Technical Service Bulletin:
TSB220176

Safety Campaign #4935 C500D6RE Door Switch Logic Corrective Action

Product Affected

- C500D6RE

Figure 2, Control Box

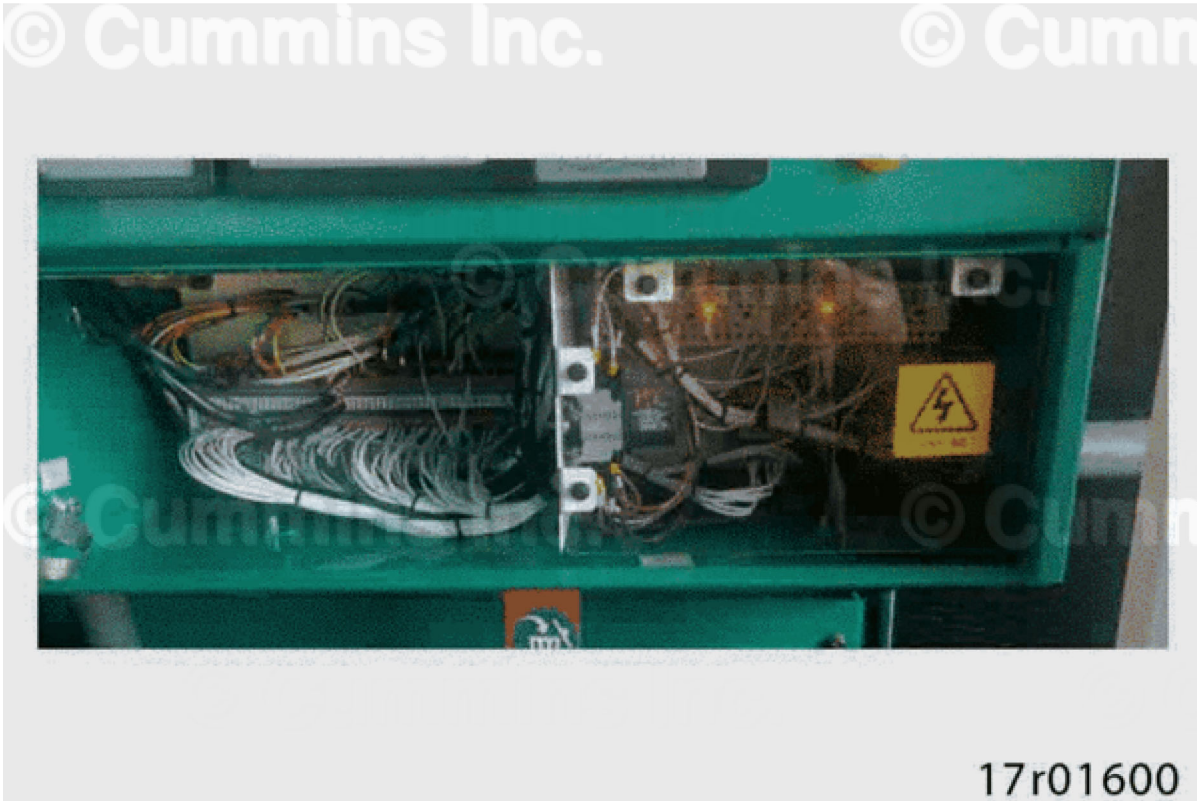
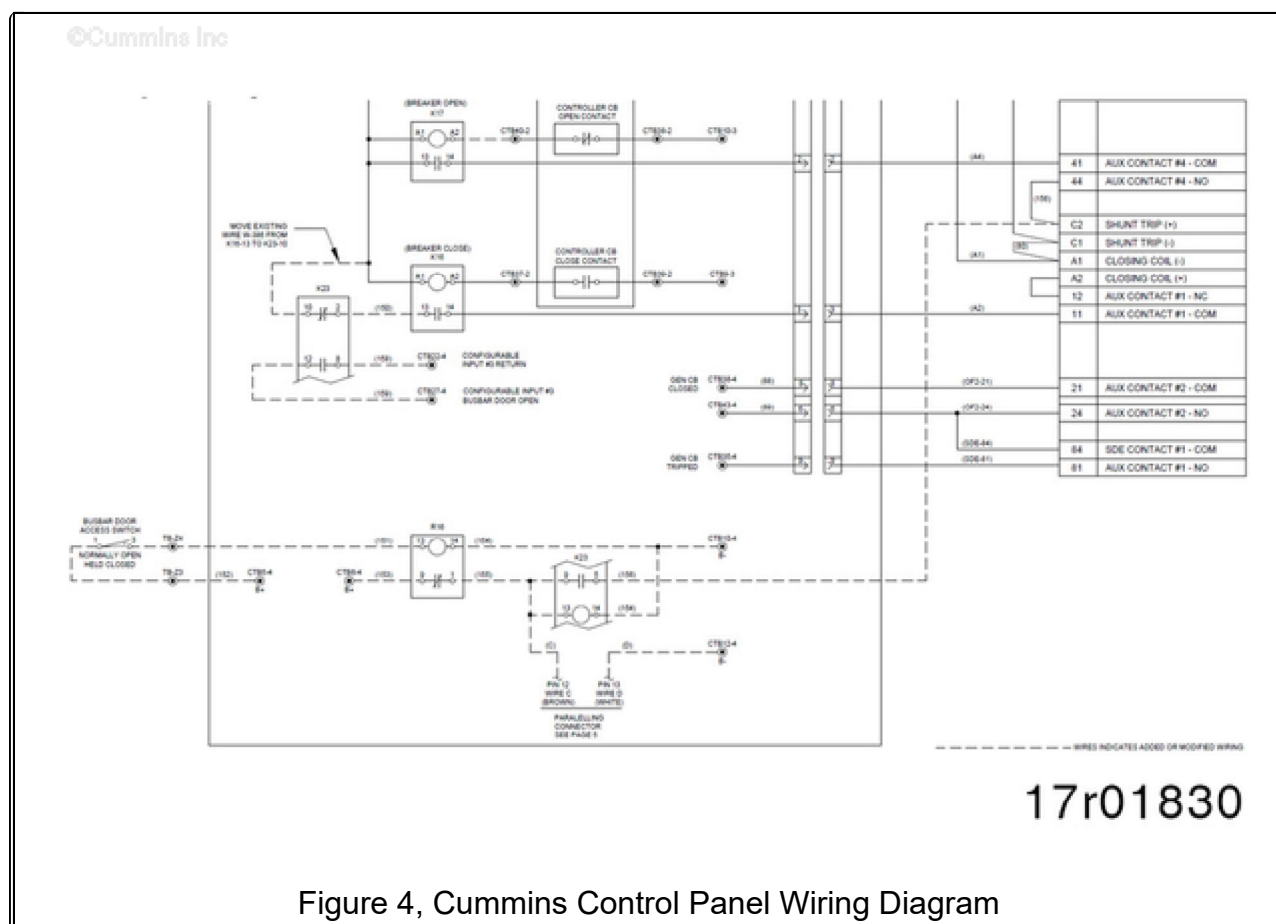
3. Using the Din rail included in the kit as a template, drill 4, 1/4" holes and mount 4" din rail to the divider panel inside the control box behind the roadside rear access panel. (Mounting hardware not included)

Figure 3, Mounting of DIN Rail and Relays

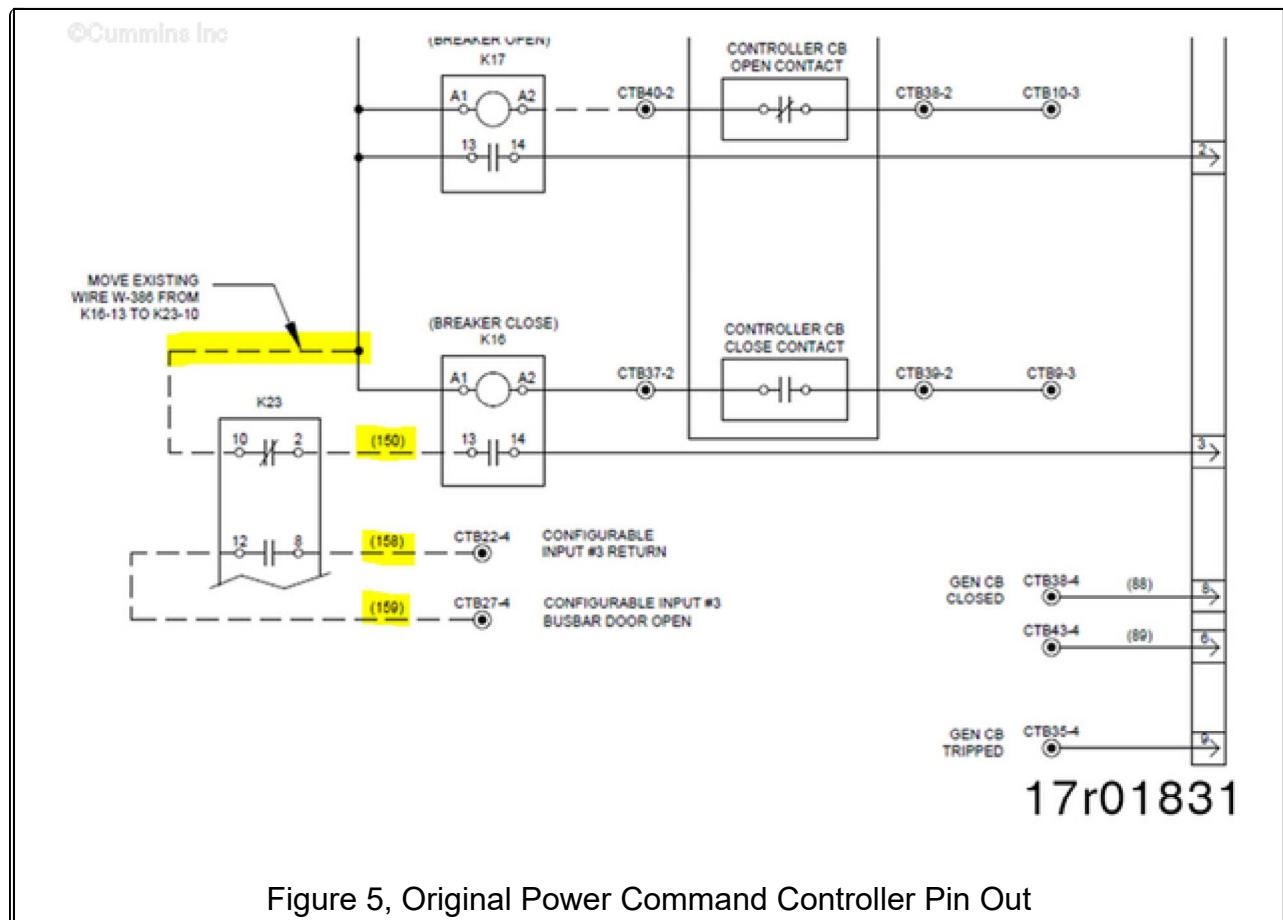
4. Place end stop, 3 pole relay (K23), 1 pole relay (R16) onto the Din rail. (See Figure 3)

Figure 7, Updated Power Command Controller Pin Out

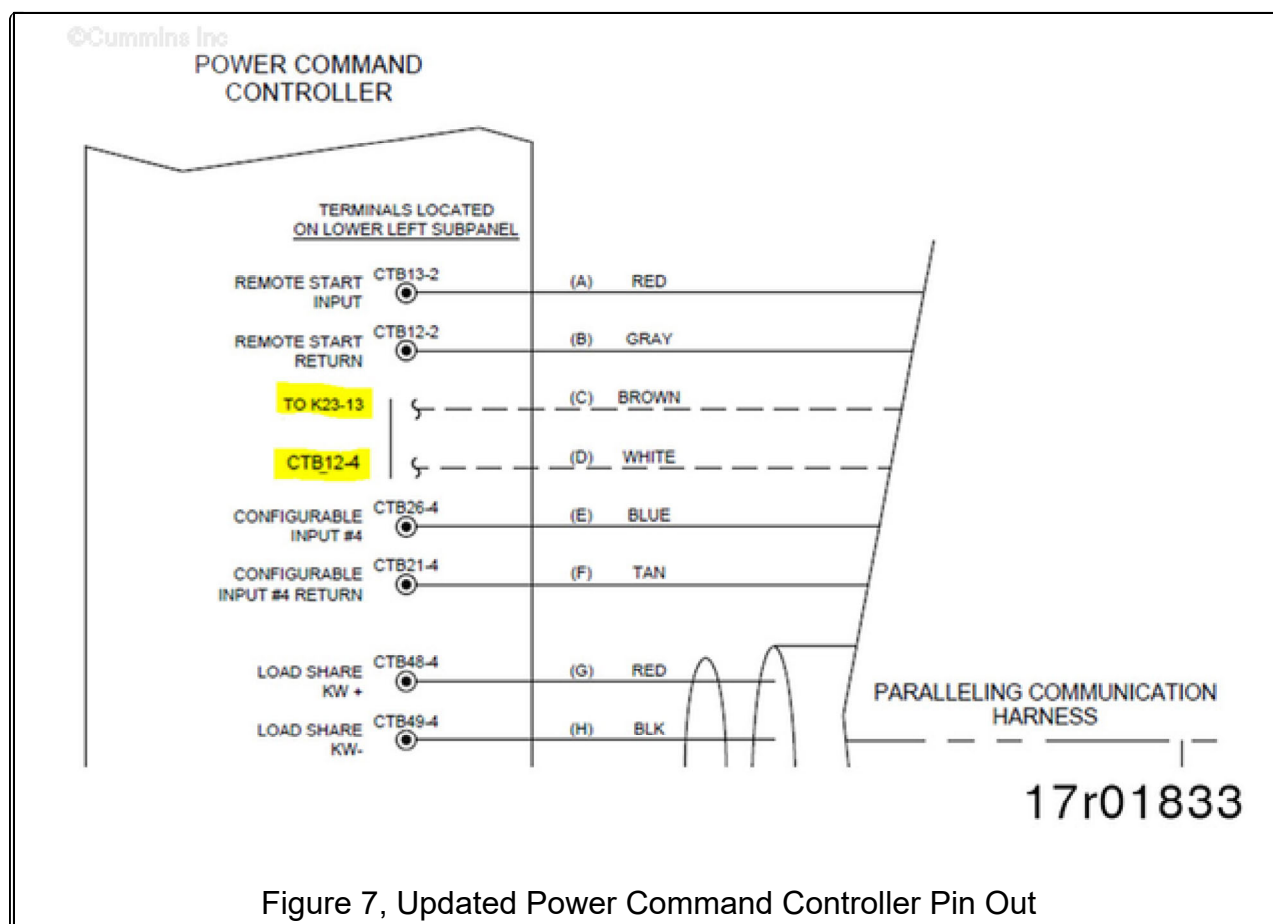
6. Remove Wire "C" (Brown) from CTB27-4 and move it to K23-13. Wire should now connect the paralleling connector to K23-13 (See Figure 6 and Figure 7).

7. Remove wire "D" (white) from CTB22-4 and move it to CTB12-4. Wire should now connect the paralleling connector to CTB12-4 (See Figure 6 and Figure 7).

Figure 8, Original Rear Panel Pin Out

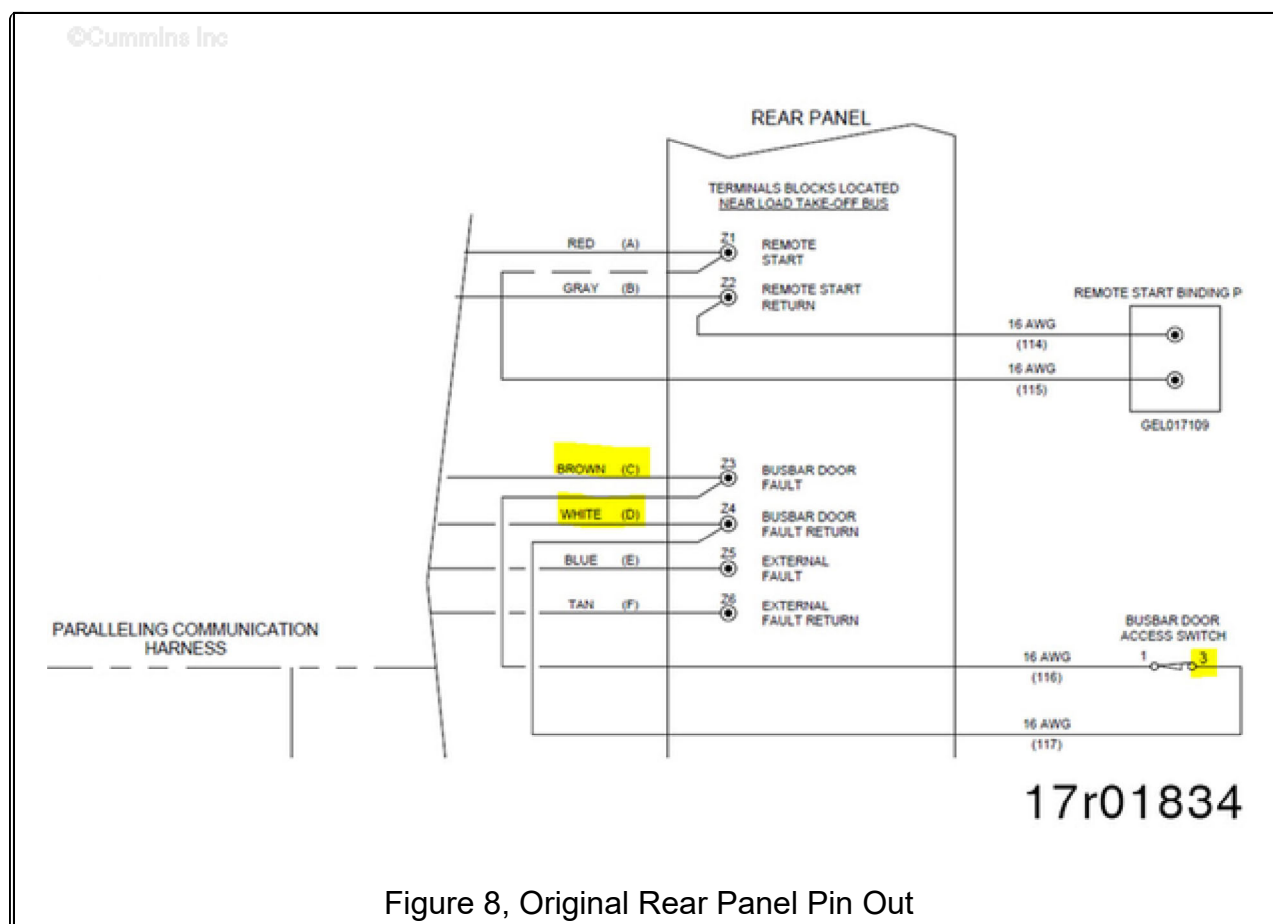
8. At the rear customer connection panel, remove the customer connection cover panel and remove wire "C" (Brown) from TB-Z3 and move it to TB-Z14 (See Figure 8).
9. Remove wire "D" (white) from TB-Z4 and move it to TB-Z15 (see Figure 8).
10. On the busbar door switch, remove the wire from pin 2 (normally closed) and move it to pin 3 (normally open) (see Figure 8).

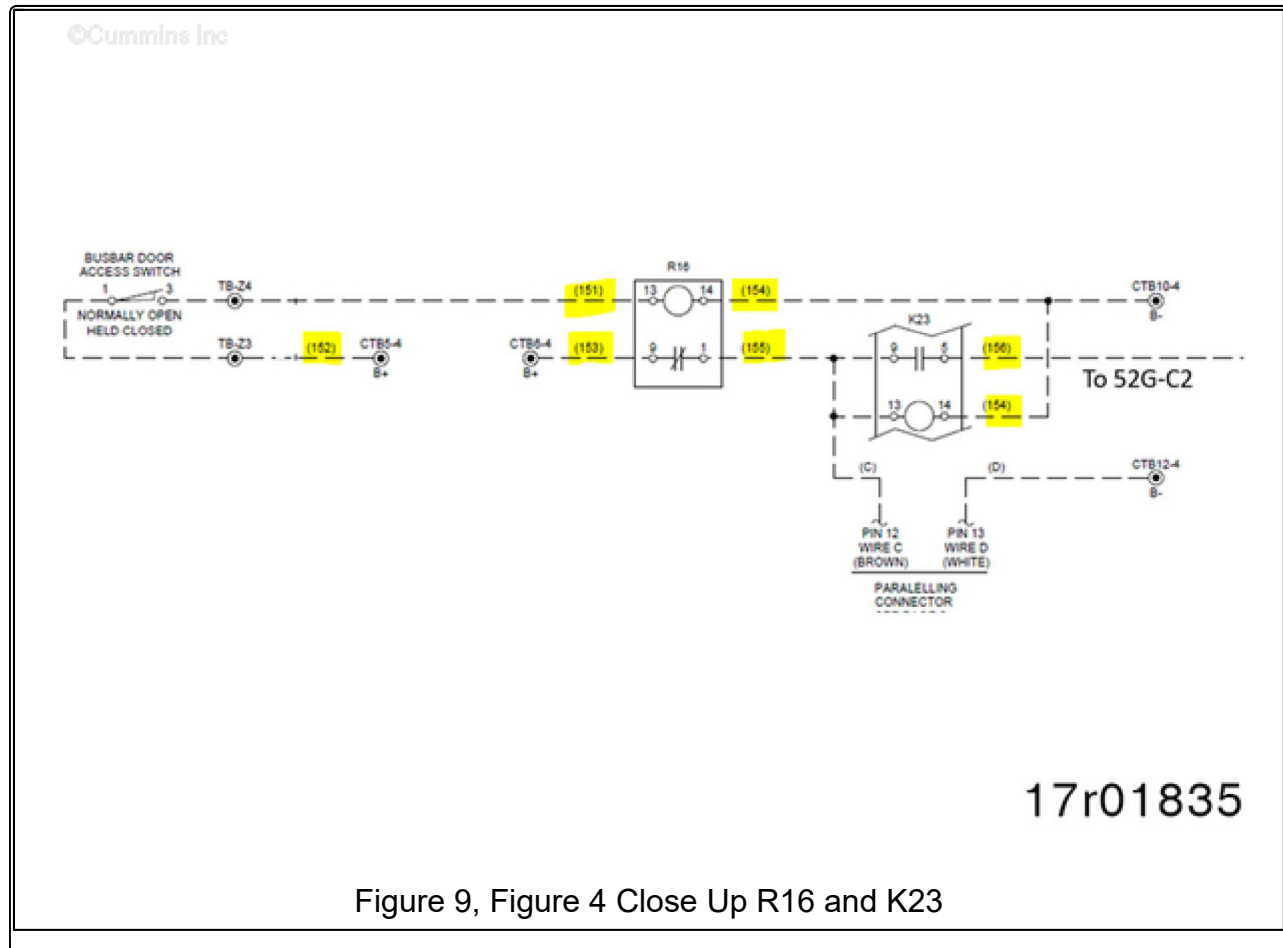
13. Wire from CTB5-4 to TB-Z3 (See wire 152 in Figure 9).

14. Wire from CTB6-4 to R16-9 (See wire 153 in Figure 9).

15. Wire from CTB10-4 to R16-14 and jumper from R16-14 to K23-14 (See wire 154 in Figure 9).

16. Wire from R16-1 to K23-9 with jumper from K23-9 to K23-13 (Double K23-13 with wire "C" and (155) (See wire 155 in Figure 9).

17. Wire from K23-5 to 52G-C2 of rear panel (See wire 156 in Figure 9).

18. Wire from CTB22-4 to K23-8 (See wire 158 in Figure 9).

19. Wire from CTB27-4 to K23-12 (See wire 159 in Figure 9).
